GEOSHIELD Verification Report

GEO101021

McAlear & Rushe

101 Charles Street

LOCATION/GRID LINE: H Block wall

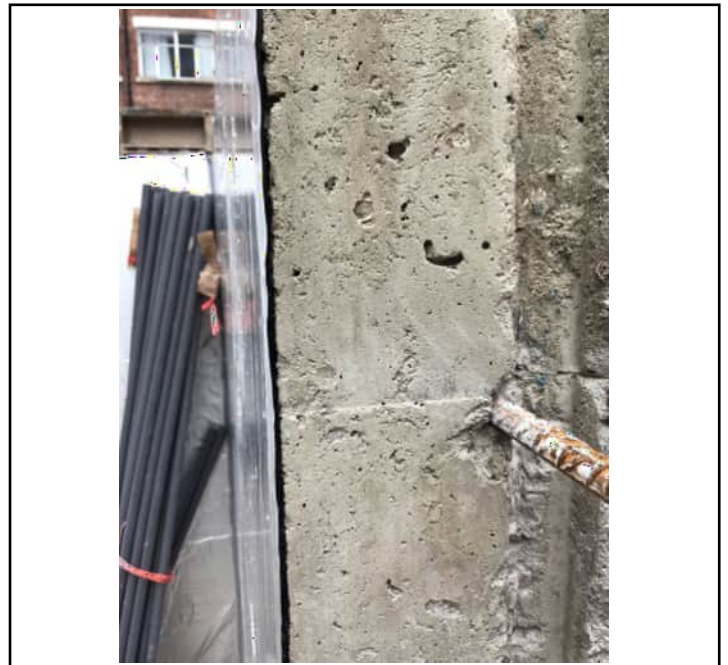
NOTES: The walls of H Block have been primed with bitumen and

GR SAM has been installed with a 300mm overlapped has been installed onto the

Concrete slab. A pick and probe test was carried out to ensure a good seal.

Left photo) GR SAM installed vertically with 300mm overlap on slab

Right photo) GR SAM sealed to concrete wall
